UNITED STATES PATENT AND TRADEMARK OFFICE

09/172,553

Office Action Summary	Application No. 09/172,553	Applicant(s) GREEN ET AL.	
	Examiner José R. Díaz	Art Unit 2815

DETAILED ACTION

F I G . 4 c

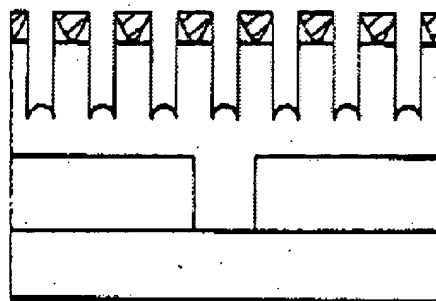
Regarding claims 31-32, 35 and 43, Jun et al. teaches an intermediate semiconductor capacitor structure (see figure 4c) comprising: a storage poly structure

(13) comprising a plurality of contiguous mesas (consider the fingers or columns that include mask 15 and HSG 14 in fig 4c) with recess formed therein (consider the space between the fingers or columns in fig. 4c); a contiguous hemispherical-grain polysilicon (14) over said storage poly structure (13) (see fig. 4c) and a mask (15) over said hemispherical-grain polysilicon layer (14), said recesses (consider the space between the fingers or columns) being exposed through said contiguous hemispherical-grain polysilicon (14) and said mask (15) (see figure 4c).

With regards to the terms "contiguous mesas" or "contiguous webs", please refer to figures 4c and 6c, below. Please note that figure 4c shows shallow recesses that do not disturb the continuity of the storage poly structure 13. Thus, figure 4c shows storage poly fingers connected throughout in an unbroken sequence.

F I G . 6c

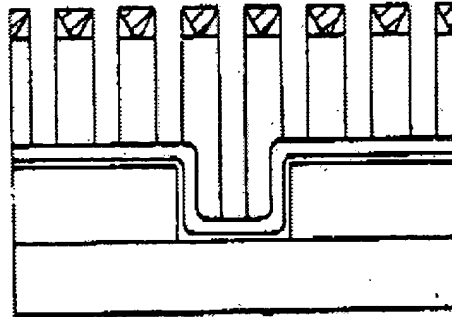
By the contrary, figure 6C shows deep recesses that disturb the continuity of the fingers. Thus, in this case figure 6c does not show contiguous fingers. Therefore, the terms "contiguous mesas" or "contiguous webs" in view of Jun et al. will be define according to

figure 4c, in which shallow recesses are provided without disturbing the continuity of the storage poly.

Fig. 22

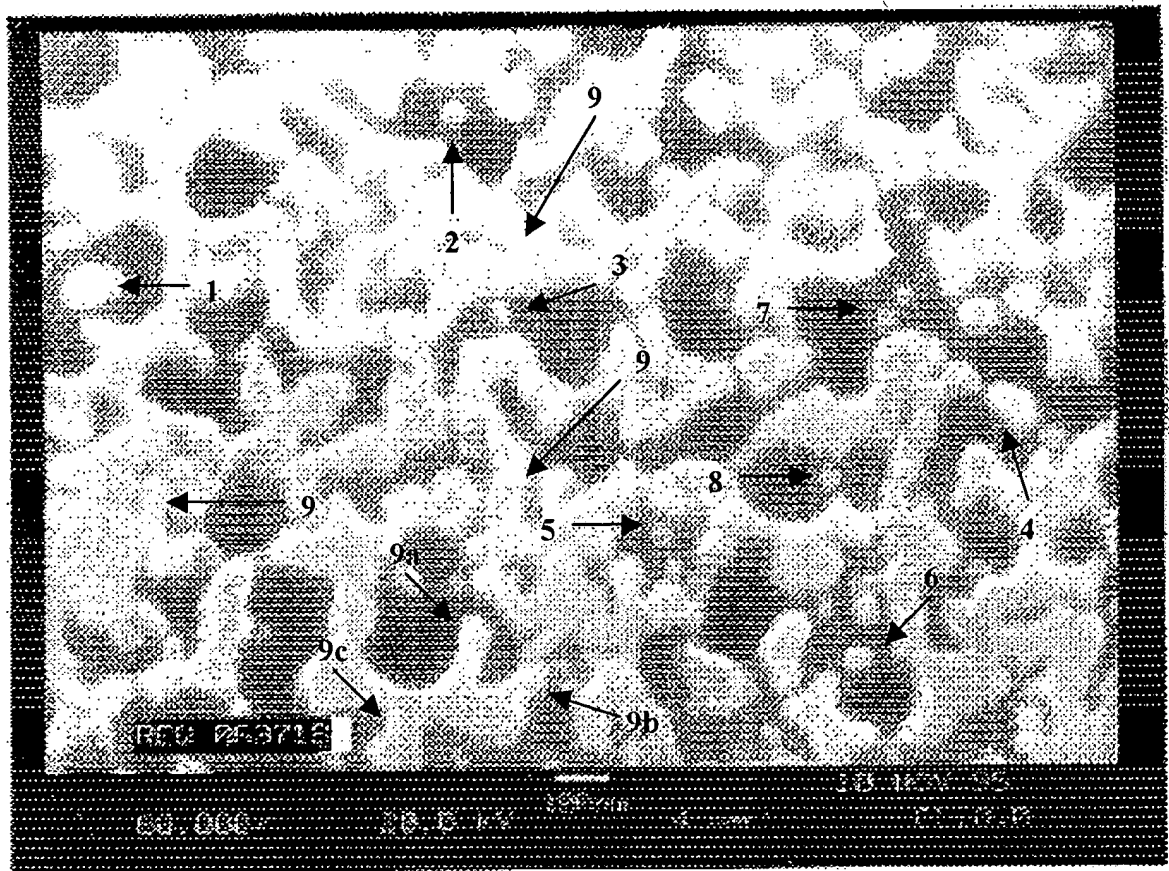
A mesa or web defined as a mere portion or region of a top surface. For example, the mesas or webs (fingers 9a-9c in figure 22, below) are “contiguous” because they share the same top surface (9).

Fig. 9

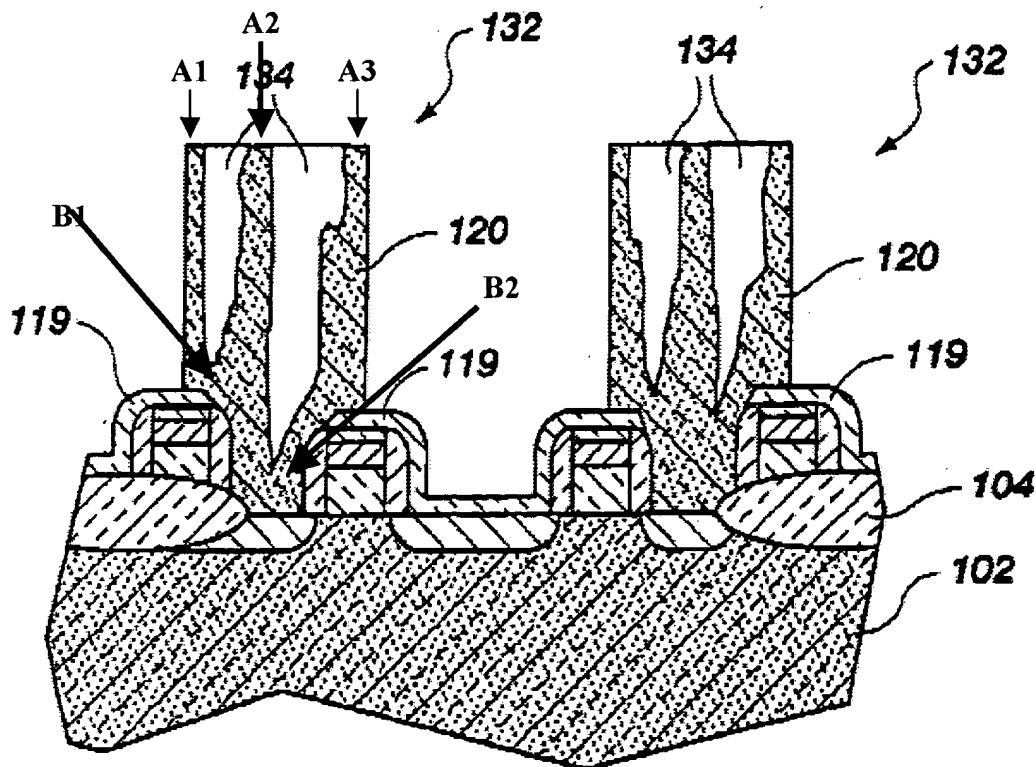
The mesas or webs are contiguous by sharing the same base. For example, top surfaces A1 and A2 share base (B1); and A2 and A3 share base (B2), which is adjacent to base (B1) (see fig 9, below).
